MFN 07-275

**Subject: Response to Portion of NRC Request for Additional Information
Letter No. 67 Related to ESBWR Design Certification Application –
Mechanical Components – RAI Number 3.9-15**

NRC RAI 3.9-15

Figure 1: Internal CRD Blowout Support Schematic (from DCD Tier 2, figure 4.6-7 with additional information)

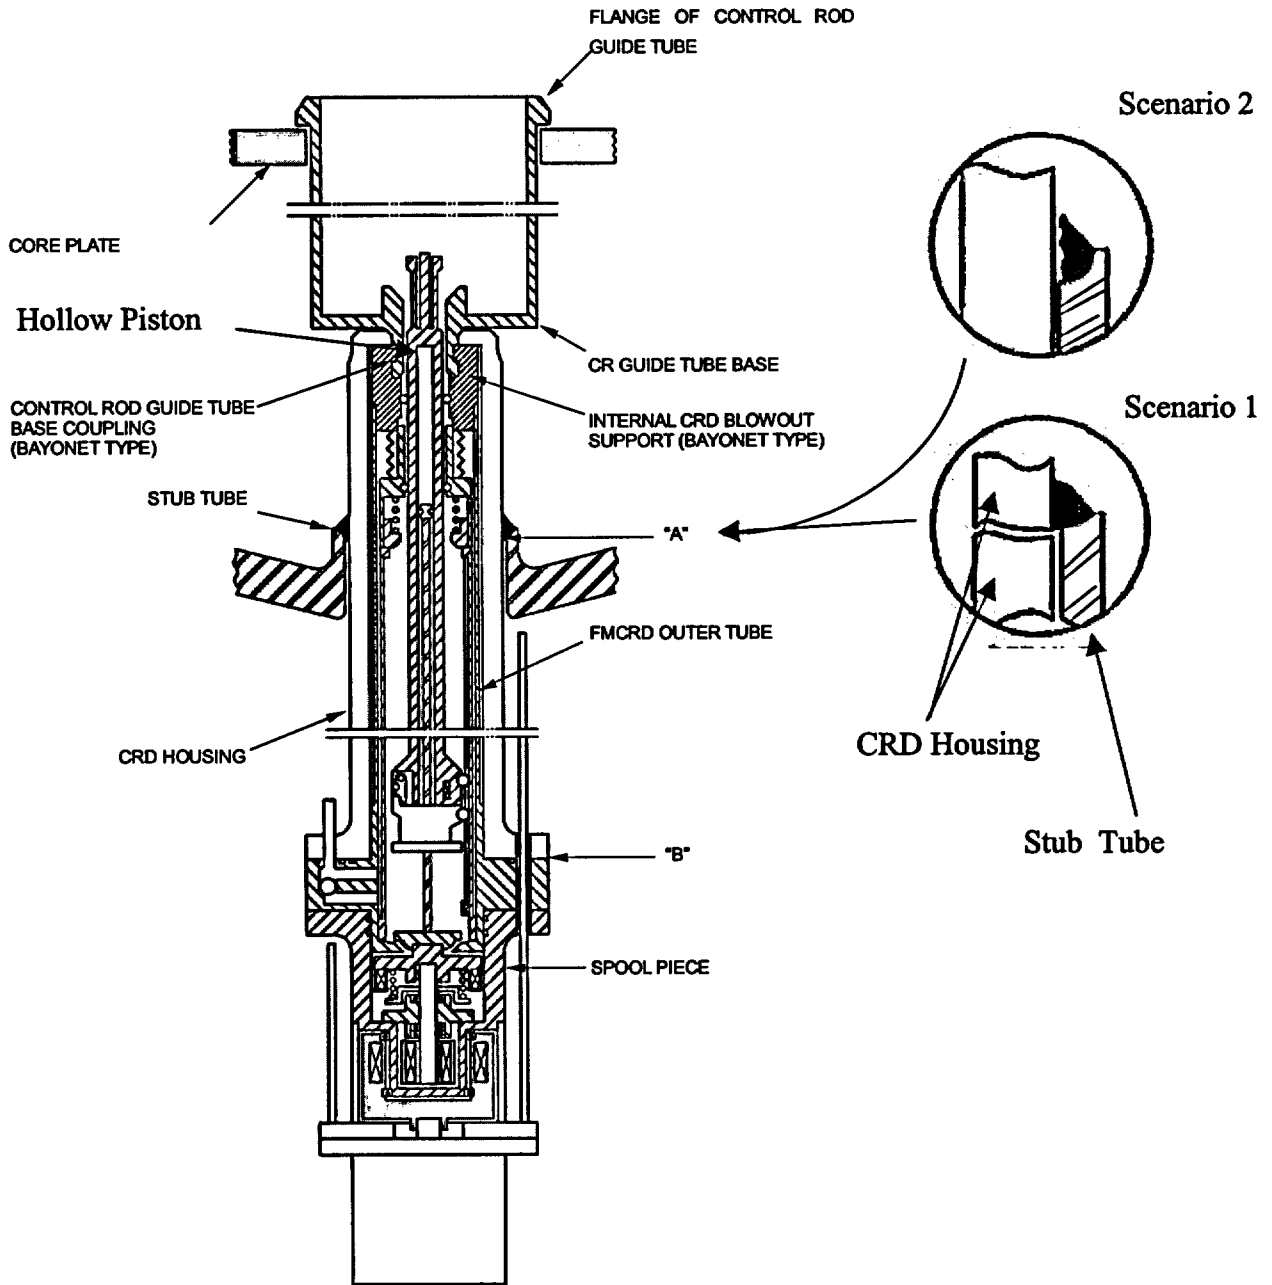
Provide a description of the application of inelastic analysis in DCD Tier 2, Section 3.9.1.4 to demonstrate the acceptability of a postulated blowout of a control rod drive housing caused by a weld failure.

An analysis was performed to demonstrate the adequacy of the CRGT (Control Rod Guide Tube) to restrain a hypothetical blowout of the FMCRD (Fine Motion Control Rod Drive) and the attached control rod as described in DCD Tier 2 Subsection 4.6.1.2.2 FMCRD Components "Integral Internal Blowout Support". The blowout event inelastic evaluation occurs during failure scenarios: (1) where the postulated failure in the CRDH (Control Rod Drive Housing) is just below the weld to stub tube and (2) at the weld interface between the CRDH and stub tube, see figure 1.

The normal functions of the CRGT and CRDH are to act as a core support structure or reactor coolant pressure boundary. After the CRDH failure, the CRGT and CRDH act to restrain the control rod and the FMCRD to mitigate accident consequences. When pressure and weight cause the small gaps to close, the impact load's energy is absorbed by the austenitic stainless steel components. A system analysis determines the impact load taking credit for elastic-plastic deformation of the CRGT base, the FMCRD outer tube and FMCRD upper guide (labeled as Internal CRD Blowout Support in figure 1).

A limit load analysis method is used to analyze the CRGT base. This method is chosen due the level of plastic bending deformation. A model is created in ANSYS and the material model uses an elastic-plastic relationship, and where the stress-strain relationship in the plastic region uses a power law. The CRGT base coupling will deform downwards and radially inwards. The FMCRD upper guide deforms radially outwards, but only a short distance until it contacts the CRDH inner diameter. The maximum load capability of the CRGT is determined and compared to the component loads during the postulated blowout for acceptability.
